**Application by Thurrock Power Limited for an Order
granting Development Consent for the Thurrock Flexible Generation Plant**

Planning Inspectorate Reference: EN010092

DEADLINE 4 SUBMISSION

Project name	Thurrock Flexible Power Generation Development		
Design note title	Geotechnical Engineering Assessment of the Proposed Statera Causeway, Tilbury		
Document reference	16946-HYD-XX-XX-GE-4001-S2-P1_Statera Causeway Geotechnical Assessment TN		
Author	Martin Cross BSc MA MSc MBA PhD CEng FICE CGeol CSci CEnv SiLC RoGEP Adviser		
Revision	Rev. 2		
Date	17 May 2021	Approved	✓

Figure 2 Plan showing causeway and berthing area

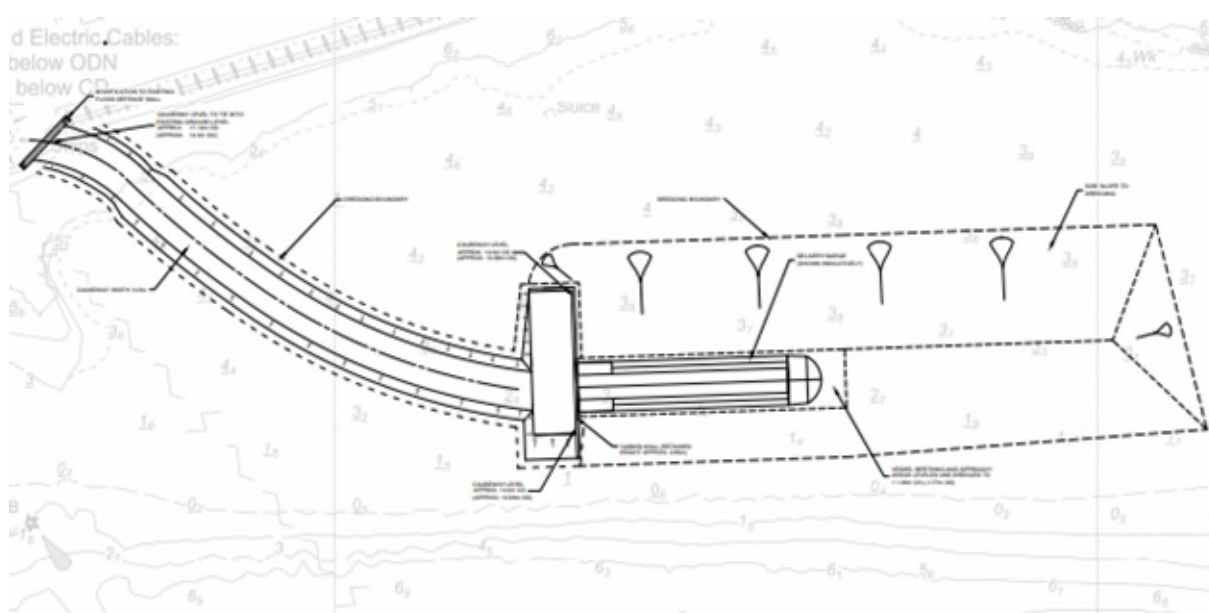
- Conceptual layout of the causeway is shown on Figure 2 and is broadly as indicated in the Wynns Limited report, except that the top width is to be increased to 12.5m to allow greater flexibility to accommodate the swept path required by the AIL transport vehicles (see Figure 3).

AECOM describe the process of constructing the causeway. This involves the removal of the very soft foreshore sediment. This sediment will be removed at low tide by approximately 0.5m. AECOM do not provide any detail of the type of plant that will be used to excavate the soft foreshore sediment and details of how the sides of the excavation will remain stable. It is possible that the sediment if removed by grab dredging will generate a

AECOM describe that the excavation will be backfilled with crushed rock fill placed on a geotextile (to prevent the rock sinking into the bed material below). AECOM do not provide any information on the type of geotextile to be used below the rockfill or the specification of the rockfill to be used at the base of the causeway. The causeway is then formed from further crushed rock aggregate, reinforced by one or more further layers of geotextile. Again, AECOM does not provide a specification of the 'crushed rock aggregate of geotextile reinforcement to be used for constructing the causeway. AECOM state that the longitudinal sides of the causeway will be formed to a stable slope and protected from erosion by tidal currents by rock filled reno-mattresses or suitably sized rock riprap. However, AECOM has not stated what the stable slope will be and do not provide specifications for the rock filled reno-mattresses rock riprap to be used on the side slopes of the causeway.

Figure 3 Typical cross section of Causeway structure

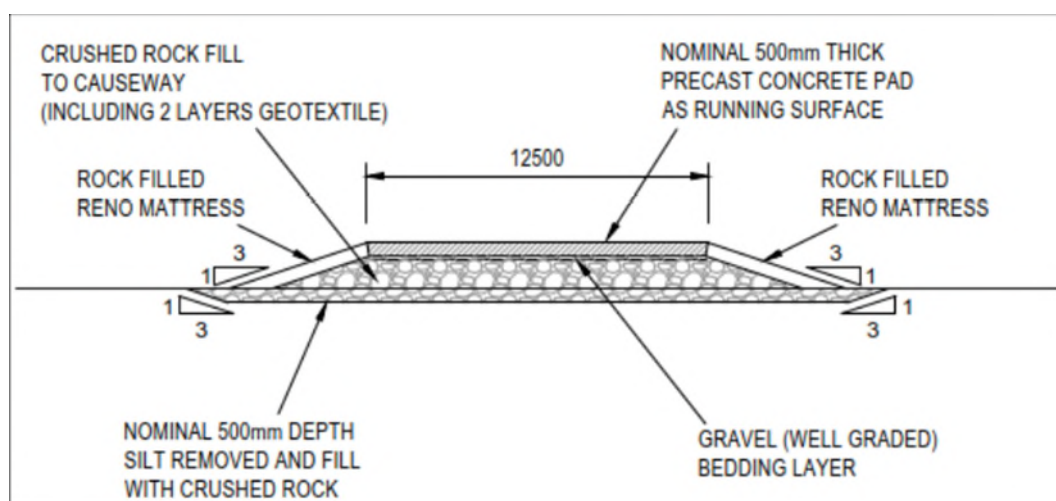
9. The current assumption to construct 1:3 side slopes for the causeway is questioned by AECOM, the concept designer. There is currently no ground investigation data to justify whether these slope gradients can be constructed at all. As there is no geotechnical data available no stability analyses can be carried out to support the conceptual design of the causeway side slopes.

10. No geotechnical data or geotechnical analyses are provided in the conceptual design report to support the design of the gabion wall and crane pads to be located at the end of the causeway.

A 1:3 (vertical: horizontal) slope has been assumed for the sides of the causeway; however, no geotechnical parameters or stability analyses are provided to rationalise this assumption within the conceptual design report. AECOM consider that side slopes of 1V:3H will be unstable, especially in an area subject to strong tidal currents as in the Thames estuary. Therefore, the current assumption of 1:3 (vertical: horizontal) side slopes for the causeway is already highly questionable. As discussed in section 5.1 and 5.7 a ground investigation is necessary to provide appropriate geotechnical parameters for the design of stable side slopes for the causeway. Hydrock consider that the current conceptual design of the causeway side slopes to be unsubstantiated and that the side slopes are likely to be at lower angles in order to maintain long-term stability.
